CITY OF BERKLEY, MICHIGAN REGULAR MEETING OF THE CITY PLANNING COMMISSION

1. **AMENDMENT TO PLANNED UNIT DEVELOPMENT PPUD-01-25: The Columbia:** The applicant, Krieger Klatt Architects on behalf of WJ Ventures LLC, 2465 Columbia, 2475 Columbia, 2468 Columbia and 2476 Columbia and 2475 Cambridge, is requesting an amendment to the Planned Unit Development previously approved for a multiple-family development on the east side of Coolidge Highway, south of Cambridge Road and north and south of Columbia Road
2. **Planning Commission Liaison for Chamber of Commerce**

The applicant has submitted an amendment to the approved Planned Unit Development for The Columbia. The project history is detailed in the Community Development Department review memo.

Thank you for the review of PUD Amendment for "The Columbia" project dated "02.13.2025 Revised PUD". Below are responses to your March 3, 2025 review letter. All responses will be cross referenced with revised documents dated "03.13.2025 Revised PUD - Rev. #1".

Sheet Title:
 First Floor Plan

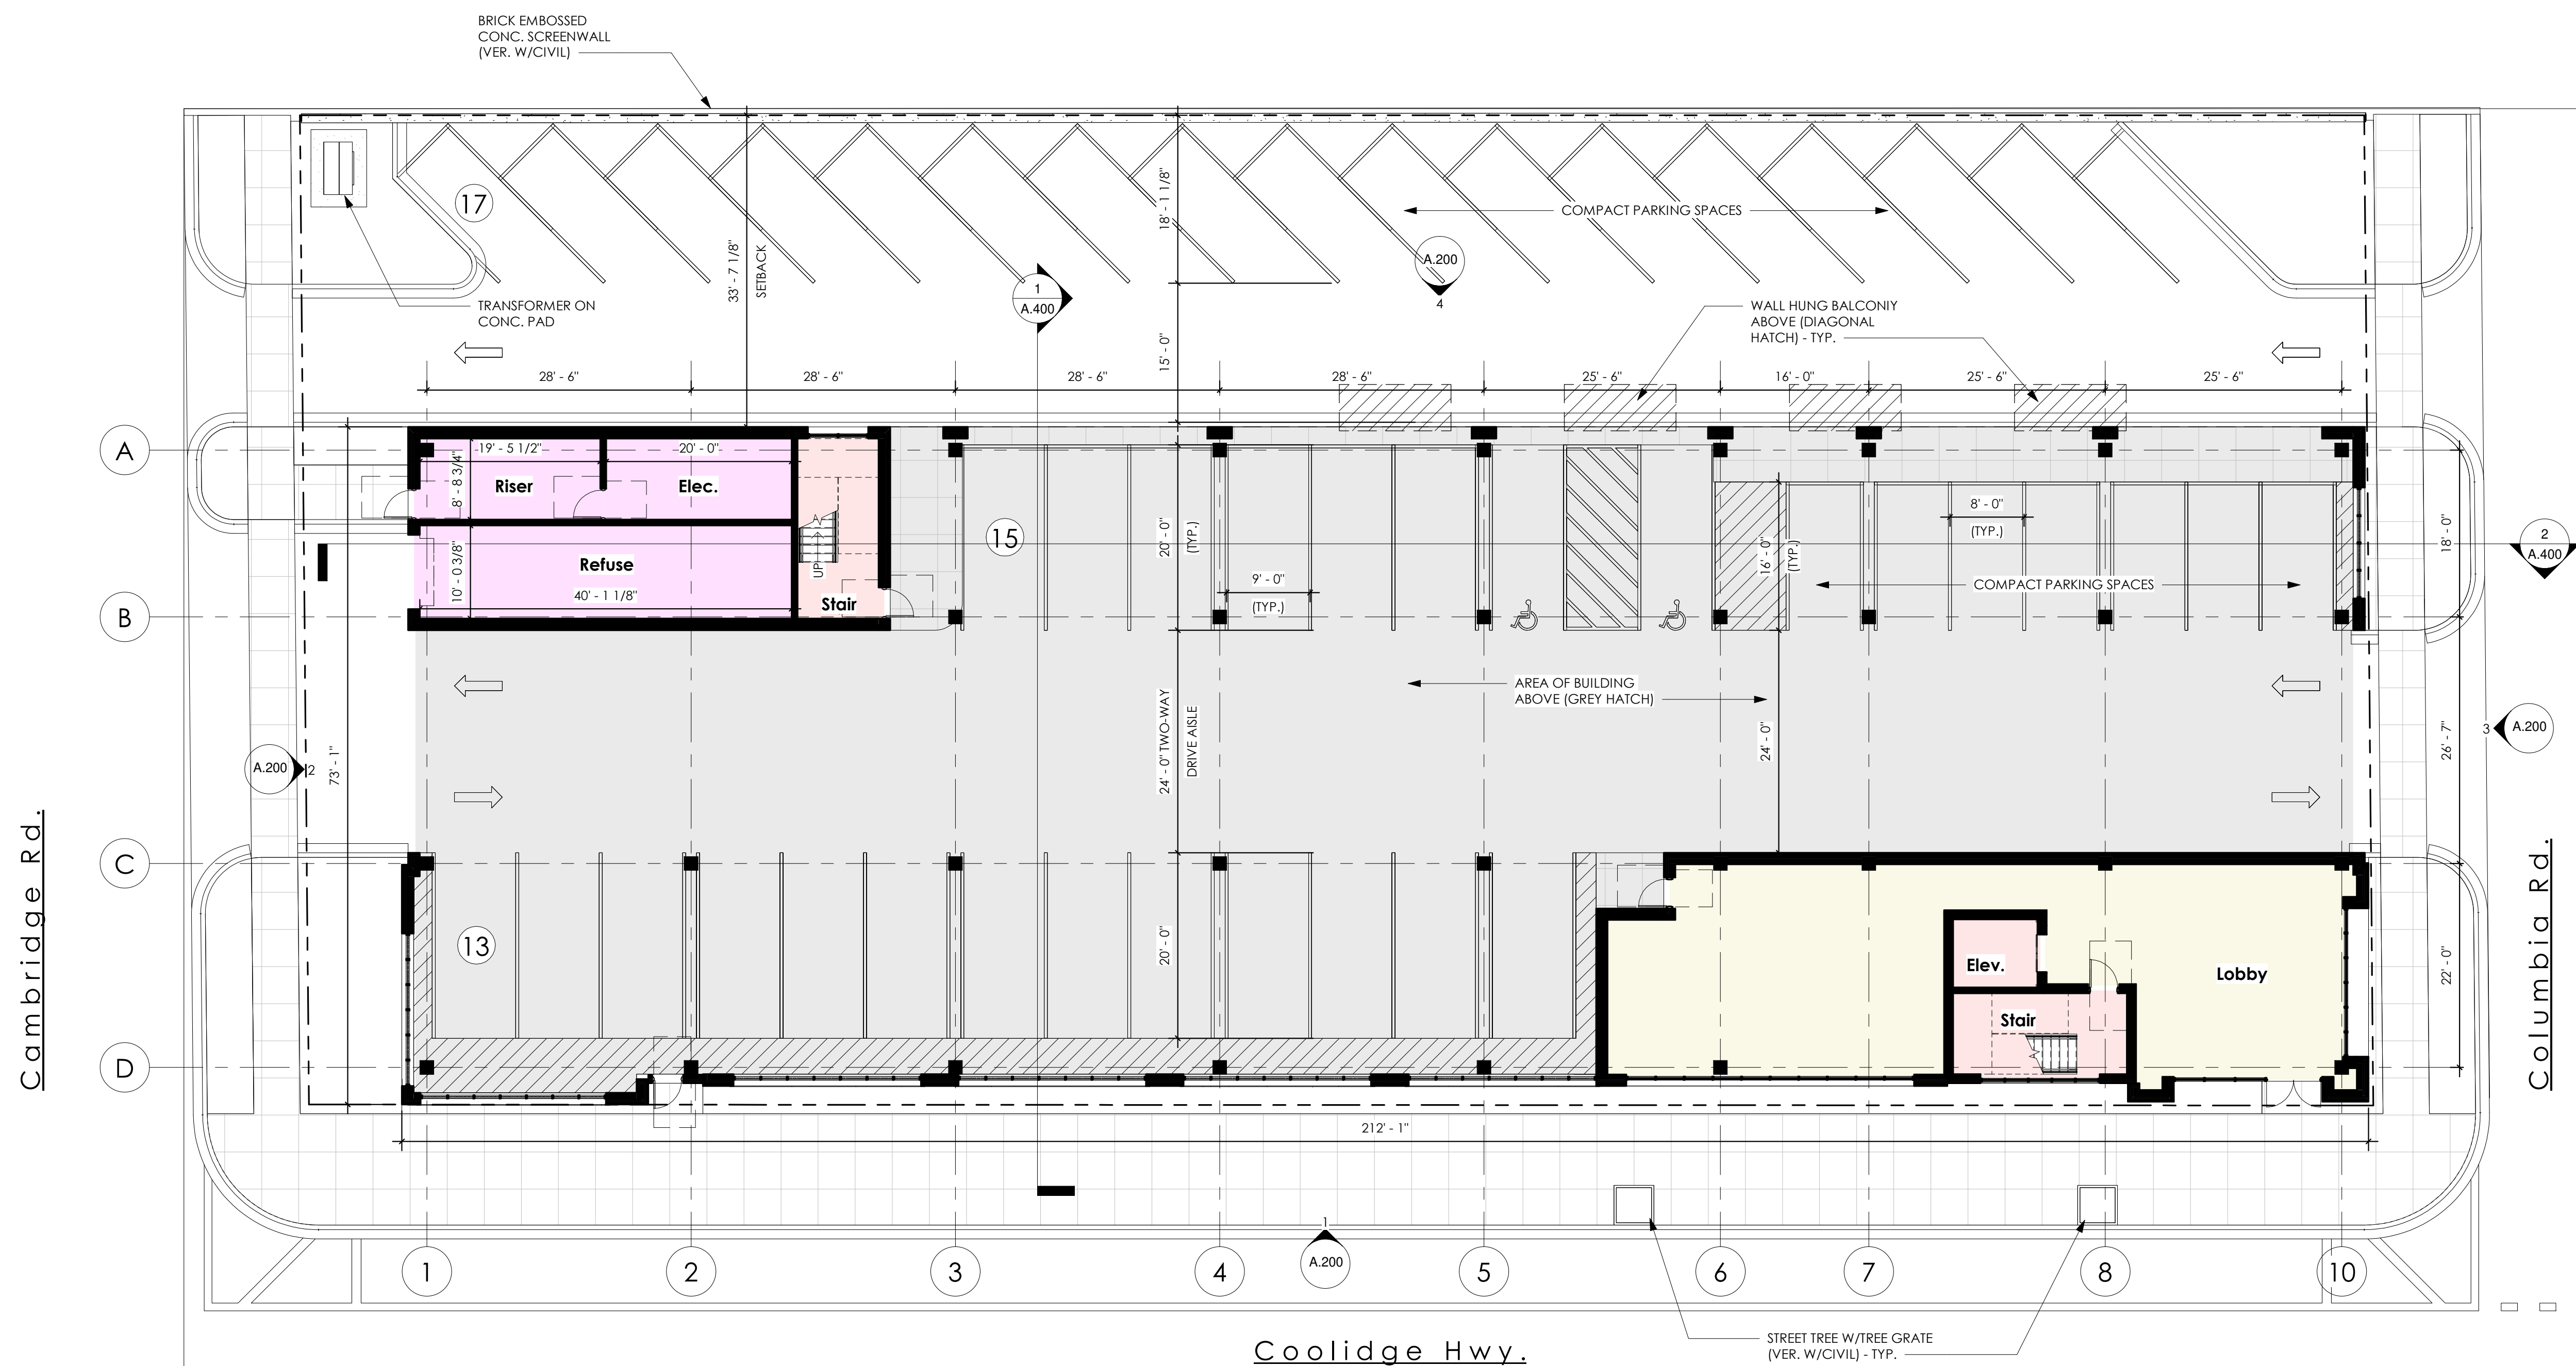
1. The number of parking spaces shown does not meet the ordinance requirements of 2 per residential unit. We will defer to Community Development to discuss the possibility of an exception to the parking requirements. This item is still applicable.
 - a. The originally approved PUD contained 57 dwelling units and 77 parking spaces. Providing a 1.351 parking ratio. The proposed plans contain 51 dwelling units and 69 parking spaces. Providing a 1.353 parking ratio maintaining the originally approved parking ratio.

5. Deficient number of parking spaces (102 required, 69 provided)
 - a. The originally approved PUD contained 57 dwelling units and 77 parking spaces. Providing a 1.351 parking ratio. The proposed plans contain 51 dwelling units and 69 parking spaces. Providing a 1.353 parking ratio maintaining the originally approved parking ratio.

Sheet Title:
Elevations

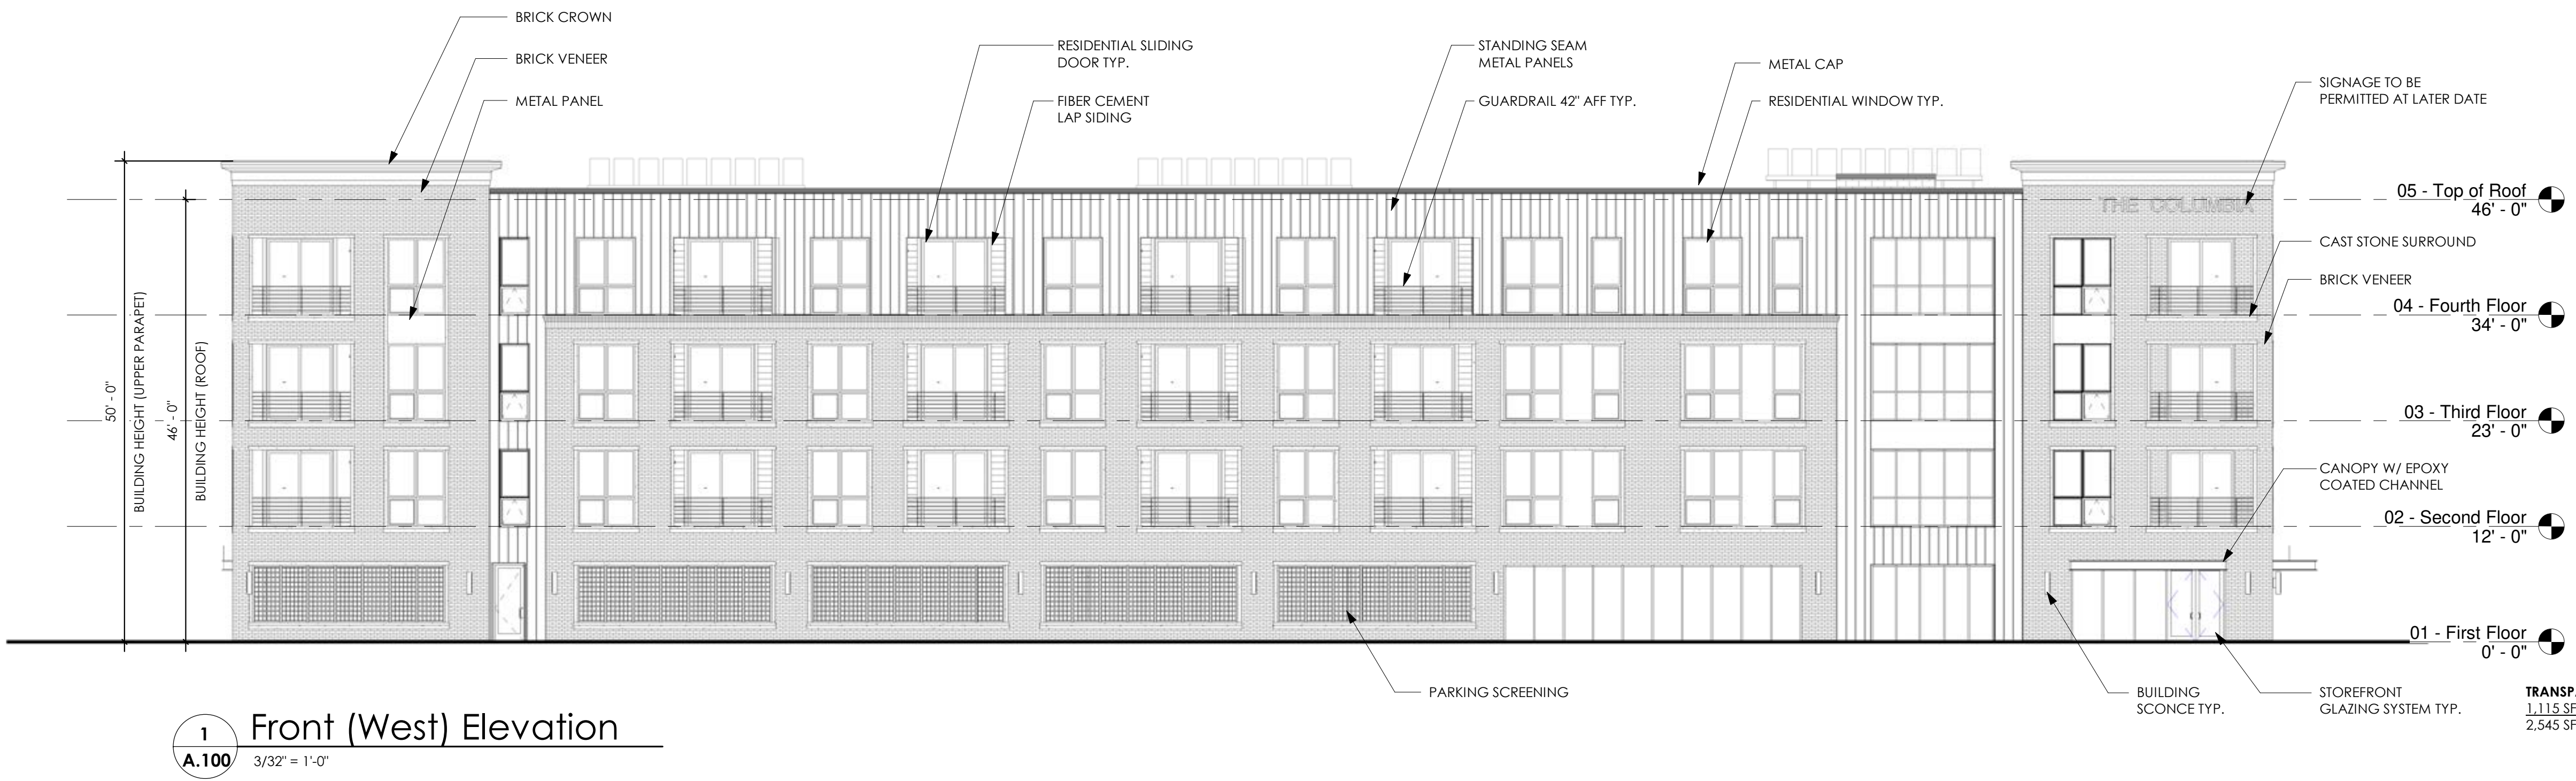
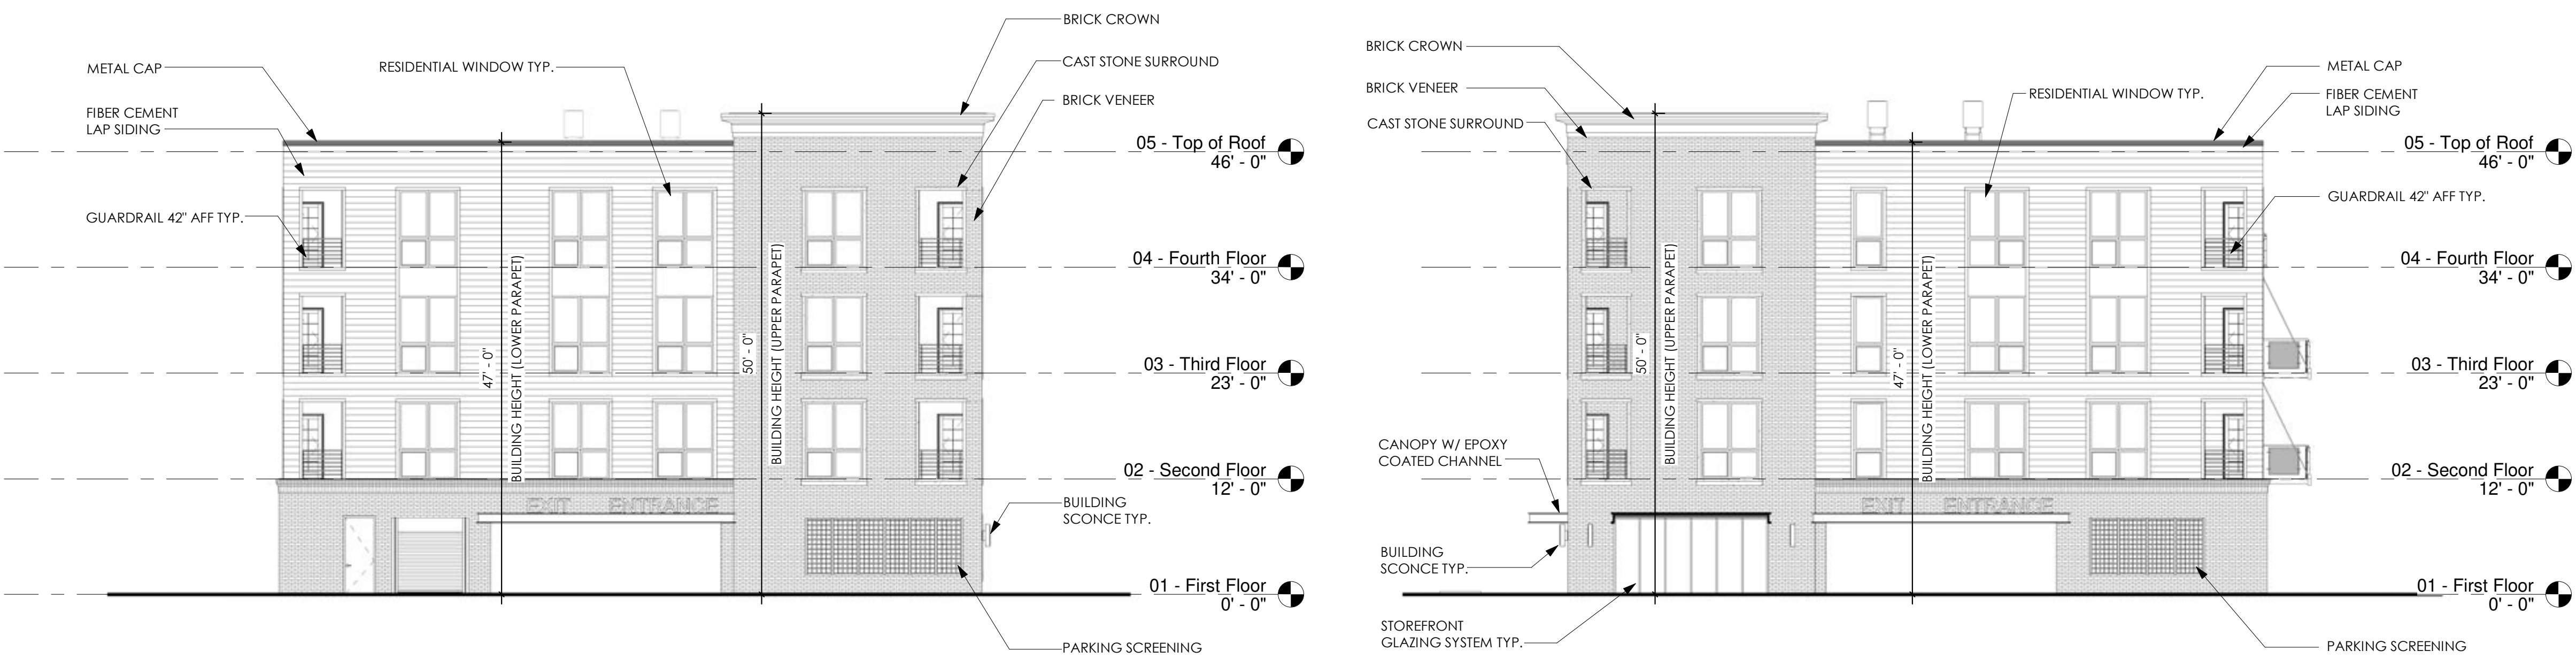
- ii. The lower parapet is set at 47'-0" (1' above the roof deck) to allow for proper waterproofing.
 - iii. The upper parapet (located at the North and South corner of the building) is set at 50'-0" and is being proposed to provide visual interest at these premier corners. Please refer to sheets **A.103, A.200, and A.201**.

- a. Please see sheet **A.200** for the dimensions being requested. The top of roof height is 46'-0", the standard parapet is 47'-0", and feature elements at the NW and SW corner of the building (facing Coolidge) have a maximum proposed height of 50'-0"
